**ADDENDUM NUMBER ONE
TO PLANS AND SPECIFICATIONS
FOR**

Henderson Park Pavilion 804 Old N. Market Street Brenham, Texas

August 13, 2026

Site Plans
A1.1
6 OF 11

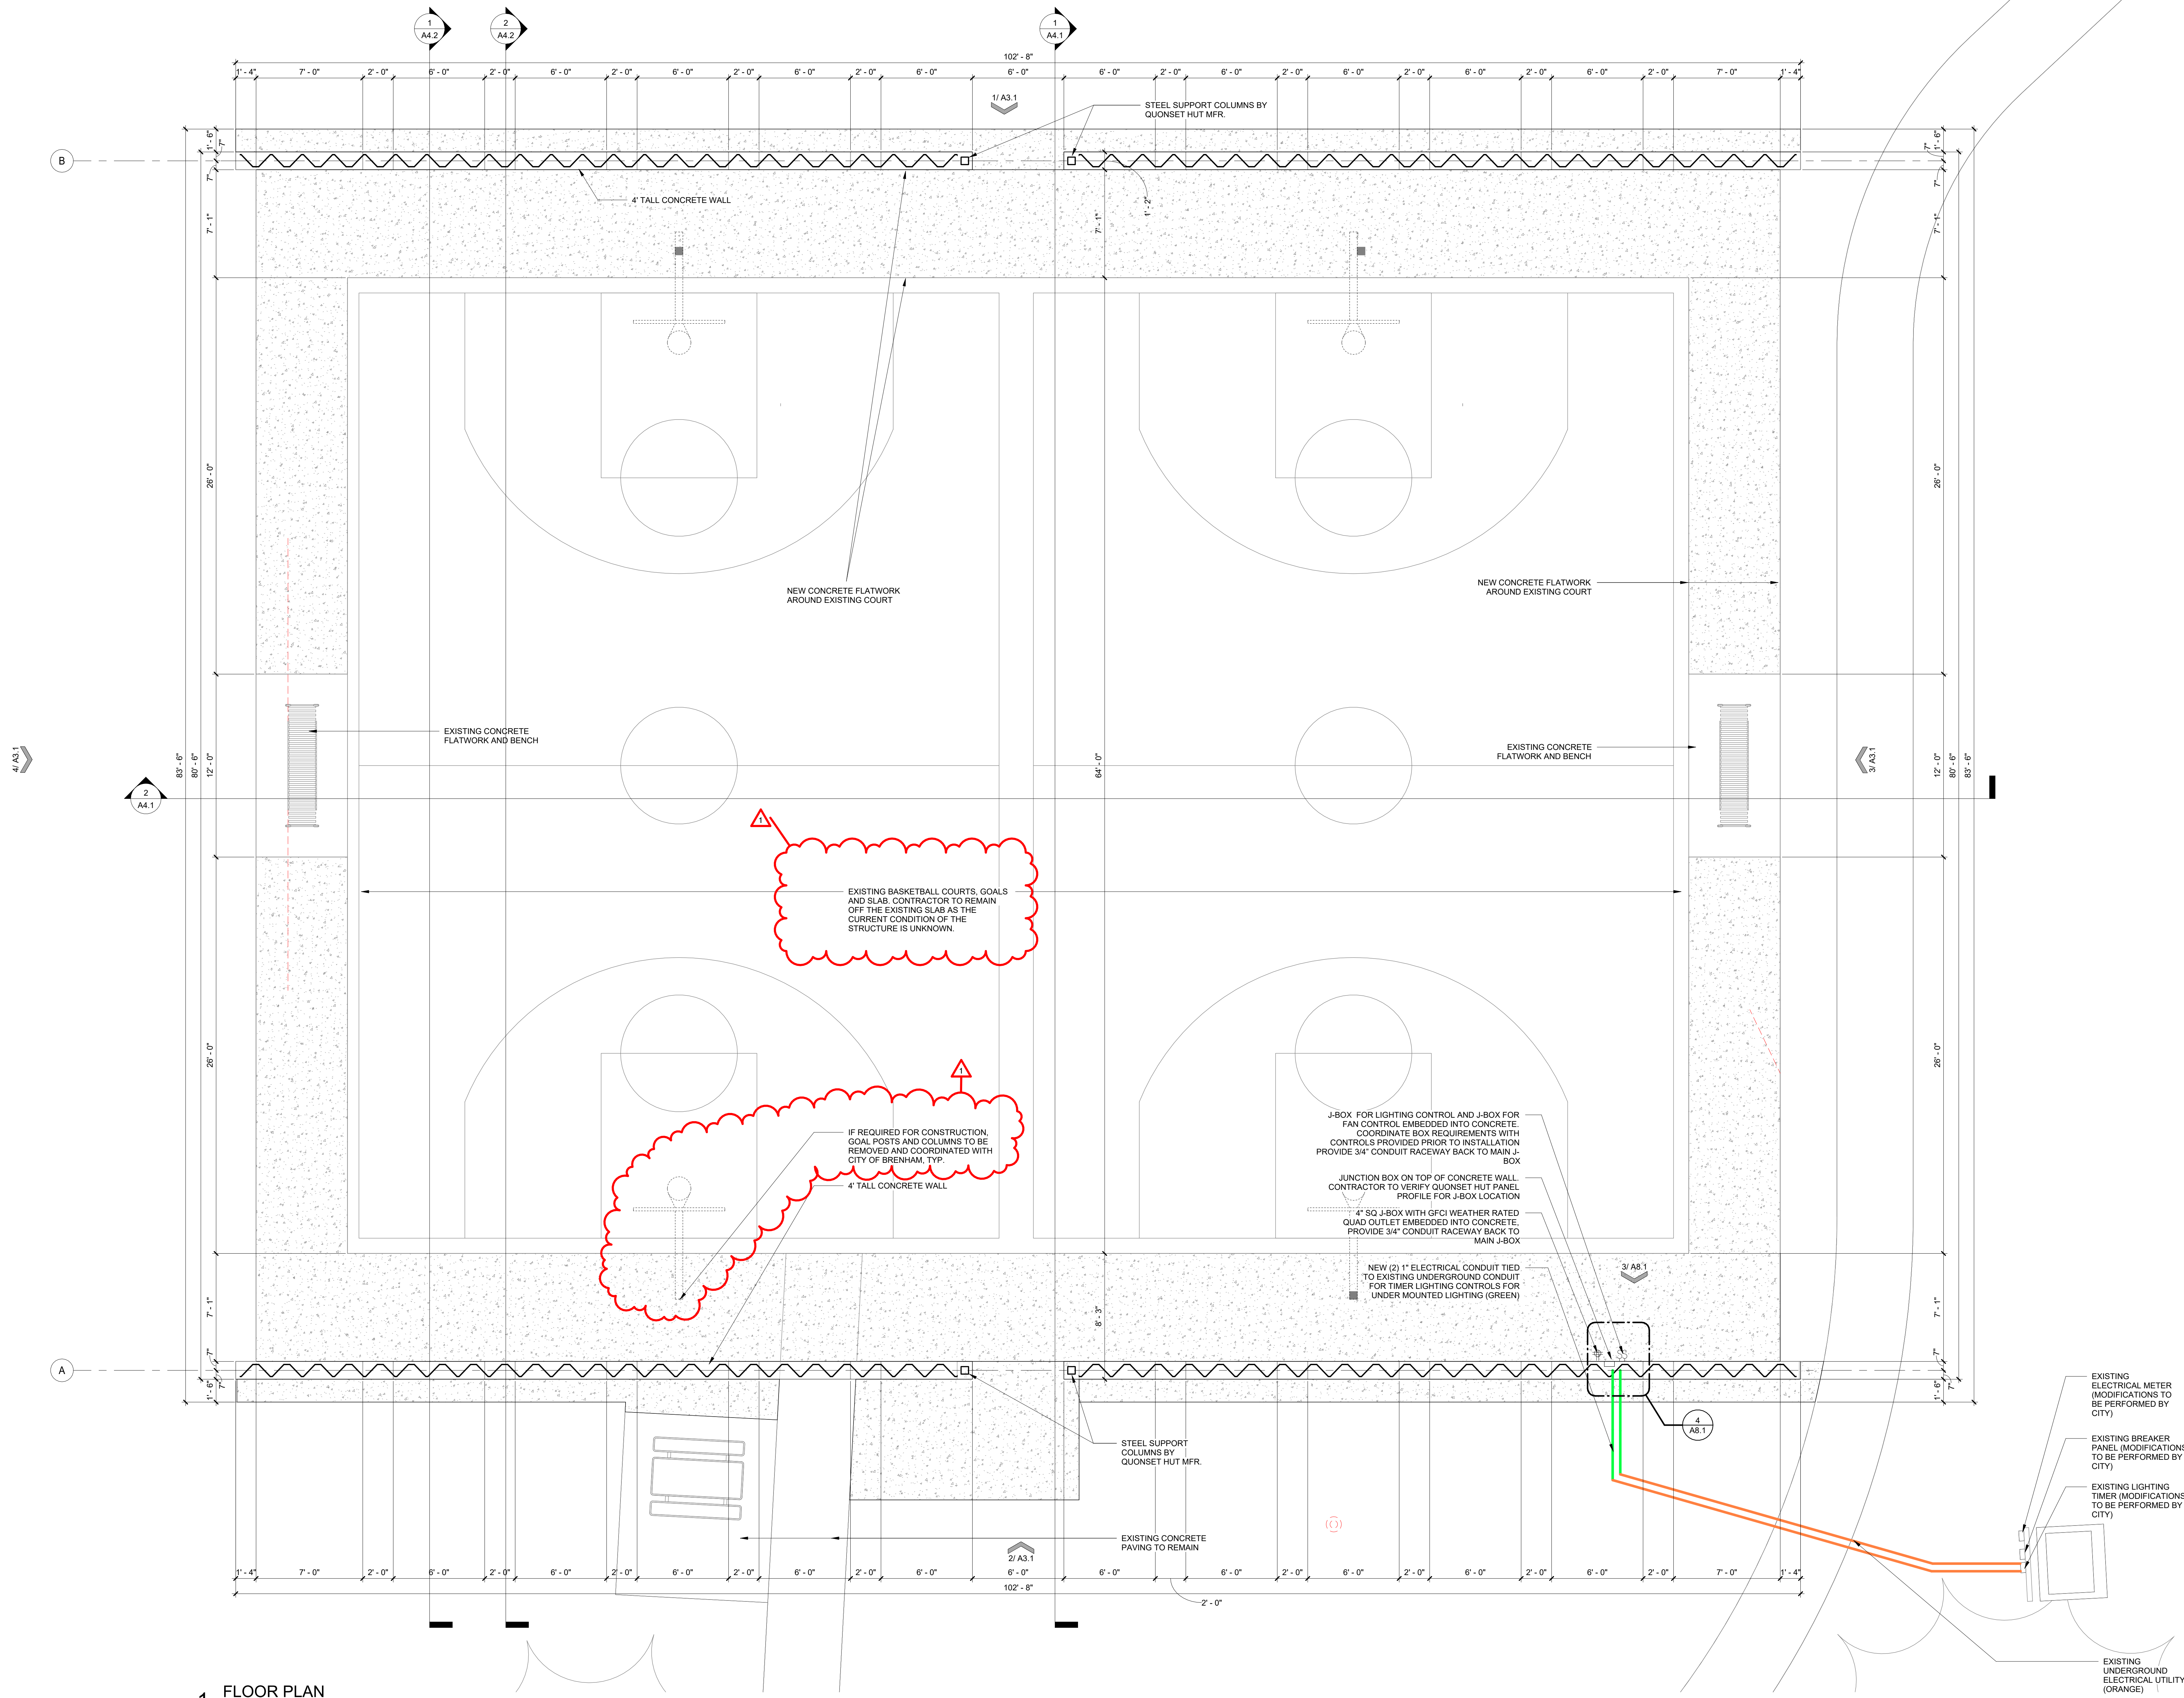
15. **CLARIFICATION:** Area available for fencing and lay down is shown on sheet 2/A1.1 in the designated FIVE parking spaces.
16. **CLARIFICATION:** Permitting required however fees to be waived as is Tax Exempted.

7 STEELMASTER HANGER SUPPORT METHODS

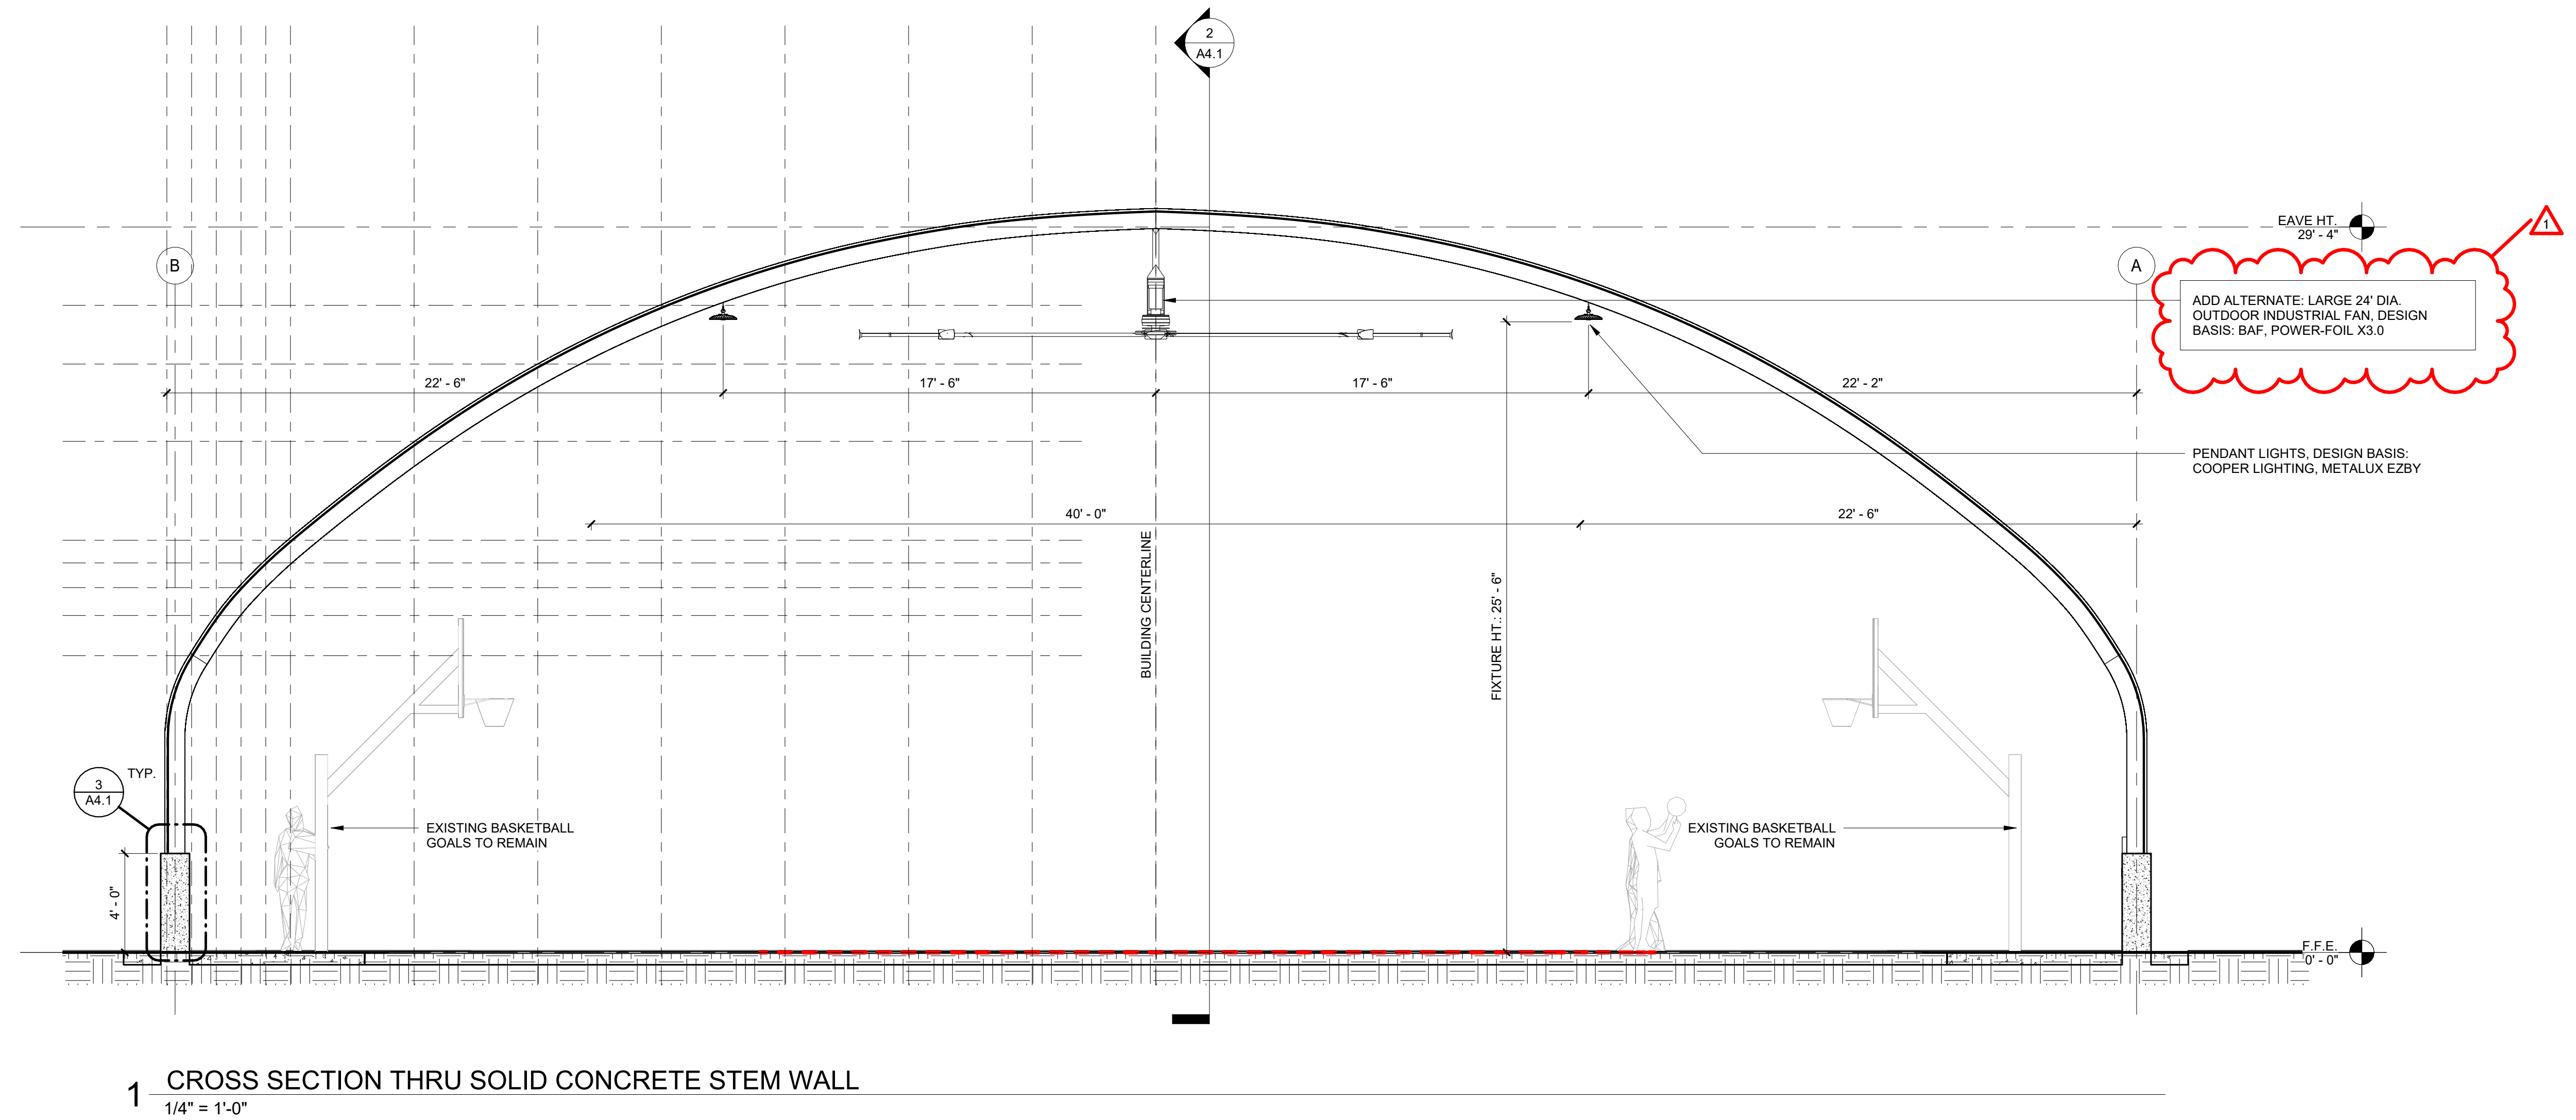
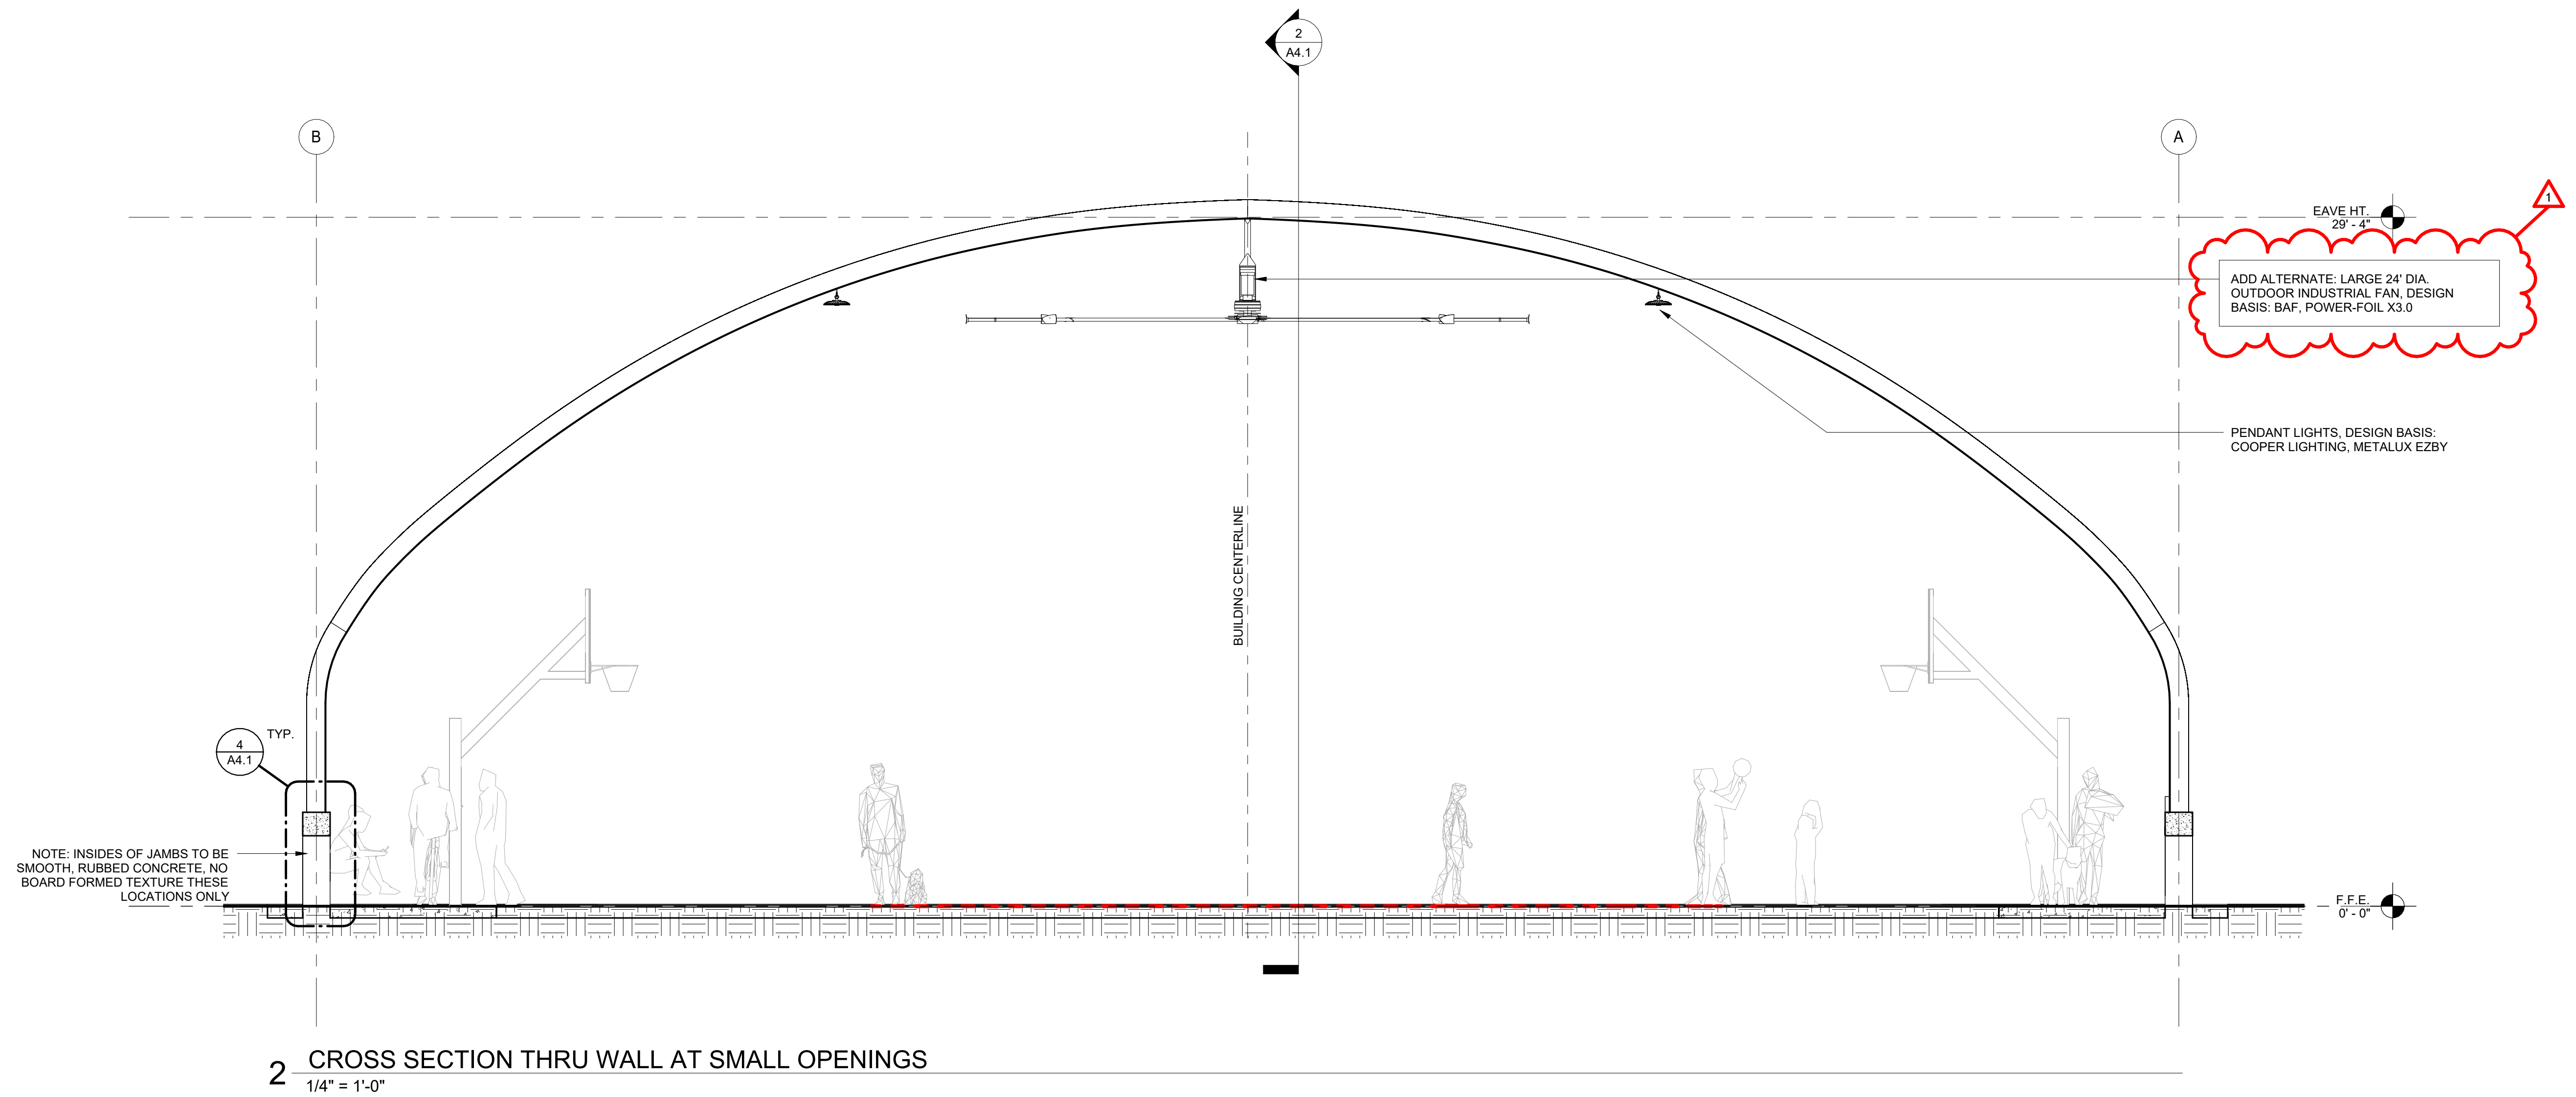
7. **CLARIFICATION:** No Structure bonding is required.
8. **CLARIFICATION:** No lightning or surge protection is required.
9. **CLARIFICATION:** 7/A4.1 detail was provided by the Quonset Hut Manufacturer (Steel Master) for conduit attachment.

10. **CLARIFICATION:** BAF's standard down-tube is to be anchored to a SteelMaster-supplied hanger. Match incoming electrical type.
11. **CLARIFICATION:** "HENDERSON" metal signage (Add Alt. 1) is non-illuminated. No Specific sign manufacturer has been selected. Material and dimensions are noted on detail/sheet: 4/A3.1.
